KIA MOTORS

MODEL
Forte w/MDPS

TECHNICAL SERVICE BULLETIN

SUBJECT: SERVICE ACTION: ECU UPGRADE FOR MOTOR DRIVEN
POWER STEERING SYSTEM (SA019)

UPGRADE EVENT NAME

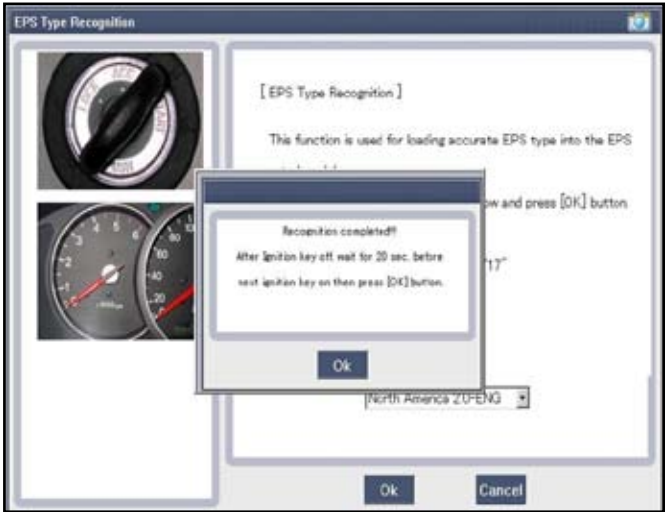
This Bulletin provides information related to an MDPS ECU software upgrade on some 2010 Forte (TD) vehicles produced between 3/3/09 and 08/19/09 that are equipped with the optional MDPS (Motor Driven Power Steering). Just after starting the engine on some occasions the "EPS Light" may illuminate on affected vehicles due to a software issue. To address this concern the vehicle's MDPS control unit should be reprogrammed following the procedures as outlined below. It is not necessary to replace the Motor Driven Power Steering Column Assembly for this concern.

95. TD Forte 10MY EPS LOGIC IMPROVEMENT
